Office Action Summary

Application No. 10/688,250		Applicant(s) TSANG, DAVID	
Examiner Thinh T. Nguyen		Art Unit 2818

DETAILED OFFICE ACTION

FIGURE 3

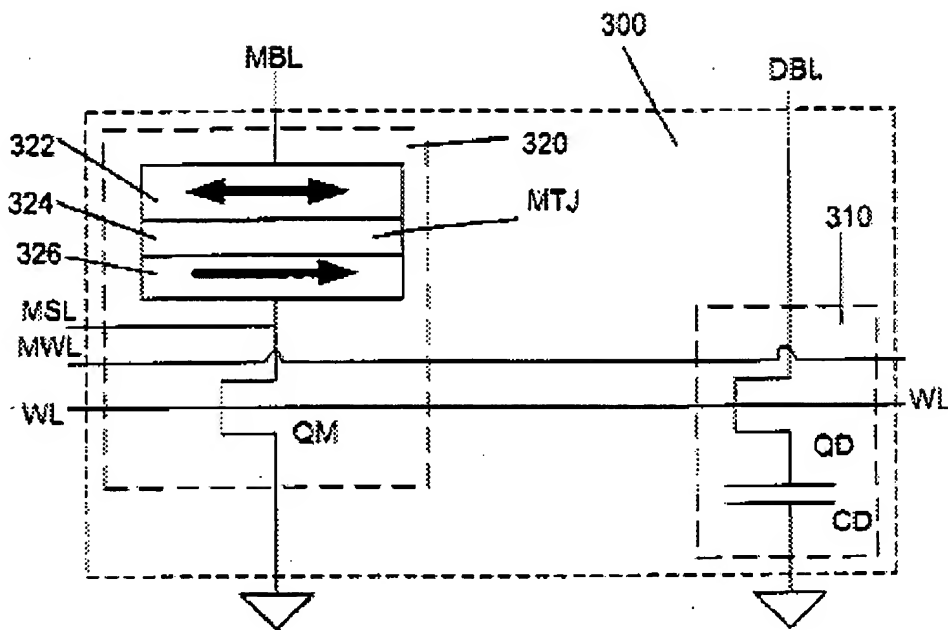
Sharma (in fig 3,fig 5) disclose a magnetic memory comprising: a plurality of magnetic elements, each of the plurality of magnetic elements having a top and a bottom; at least a first write line (fig 5 line MBL) connected to the bottom of each of a first portion of the plurality of magnetic elements; and at least a second write line (fig 5 line MWL) residing above the top of a second portion of the plurality of magnetic elements, the at least the second write line being electrically insulated from each of the second portion of the plurality of magnetic elements. And wherein each of the plurality of magnetic elements is a magnetic tunneling junction including a pinned layer (fig109 3 layer 326), a free layer (fig 3 layer 322) and an insulating layer (fig 3 layer 324) between the pinned layer and the free layer; and wherein the pinned layer is part of the at least the first write line.

Sharma (in fig 3, fig 5) disclose a magnetic memory wherein the free layer (fig 3 layer 322) resides above the insulating layer (fig 3 layer 324) and wherein the pinned layer is part of the at least the first write line. (fig 5 line MBL).

FIG. 1

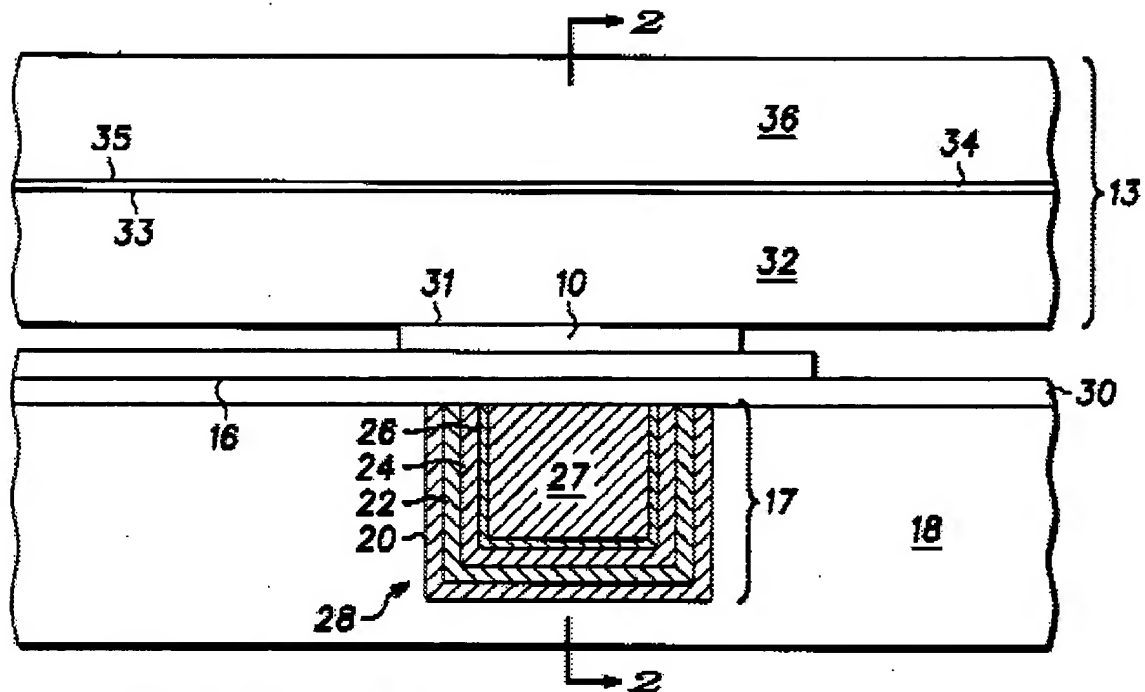
Sharma (fig 3,fig 5) disclose all the invention except for the disclosure of a cladding layer including soft magnetic material. Durlam et al.(in fig 1,column 1 line 41) however disclose a magnetic memory device that have soft magnetic cladding layer on bit line.

A person skilled in the art at the time the invention was made would haven motivated to reduce the drive current of the device invented by Sharma and make it a superior device as suggested by Durlam et al. (column 2 lines 14-15).
